Expert Opinion Report - Rectification

10-12 View Point Road, McCrae

PSM5226-005R 11 June 2024

Inset 2: Excerpt from CivilTest report 1222044-1 Issue 2 (5 December 2022) (Document 2, pdf page 4)

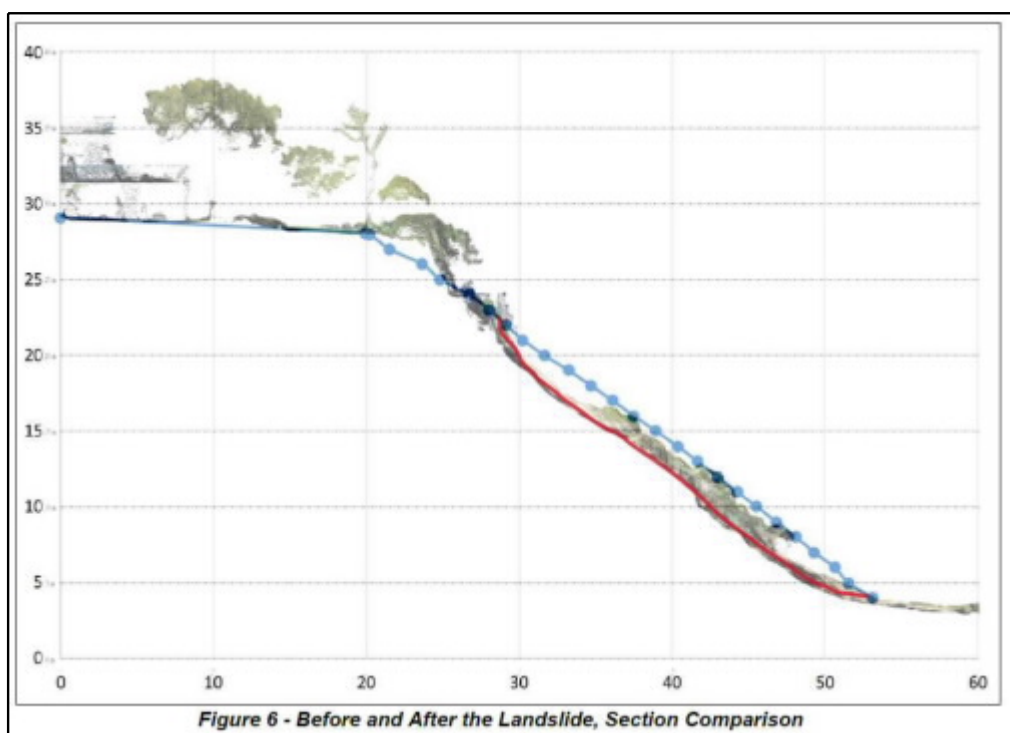
- (d) The steep head scarp depicted in CivilTest drone survey (Inset 2) and models (ref) is an artefact of creating a thick cross section line from the drone model. i.e. the head scarp feature depicted by CivilTest at the crest of the escarpment does not exist on Site (refer to Paragraph [9(a)]).

- (a) The CivilTest drone survey shows an over-steepened back scarp that was not observed during the Site visit.
 - (b) The feature survey contours show possible inaccuracies in the middle and lower slopes, with an overall convex slope profile that is inconsistent with the concave slope profile observed during the Site visit.

Inset 3: CivilTest description of debris flow as “fill” (Document 9, pdf page 3)

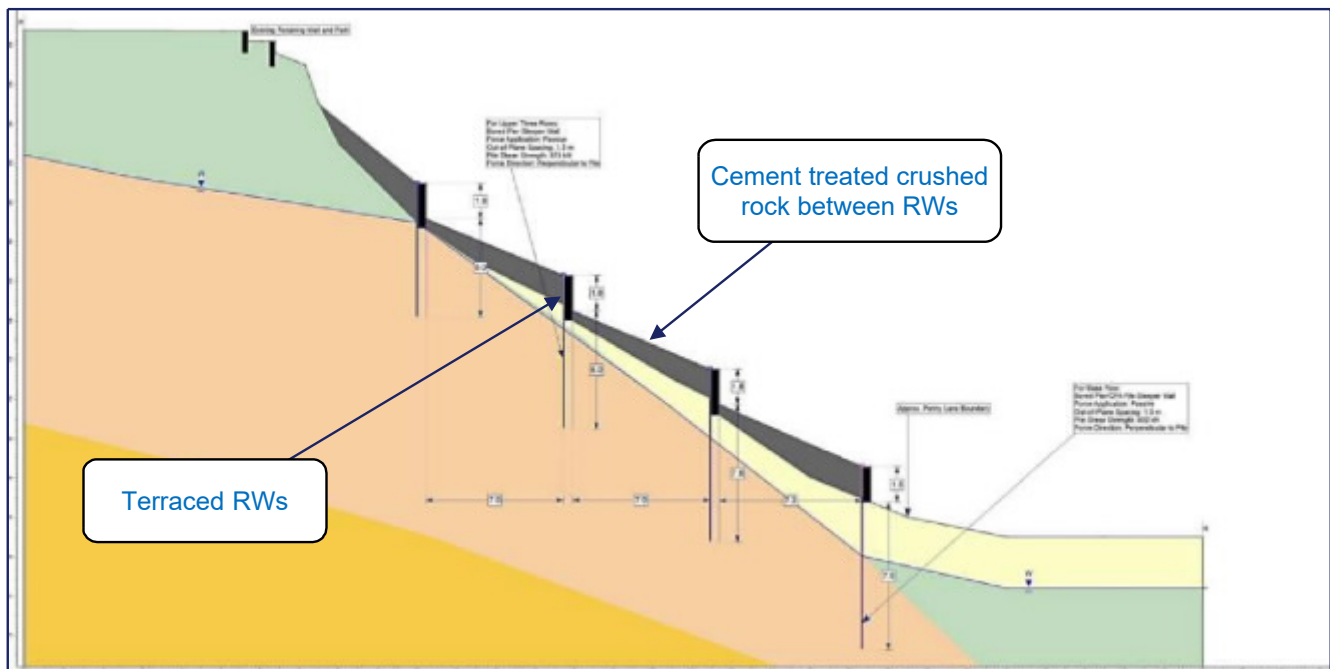
- (b) Boreholes 1 and 2 encountered landslide debris 1.2 m and 0.7 m thick respectively (Appendix C, pdf pages 29 to 30). I have assumed that all fill reported at the toe of the slope is landslide debris.

- iii. Borehole 3 between 1.8 m and 5.2 m bgl.
11. I have relied on the accuracy of the borehole log reports and the laboratory testing reports except for the assigned geotechnical units and the laboratory description of the soils. Details of my adopted geotechnical units are included in Section 6.4.
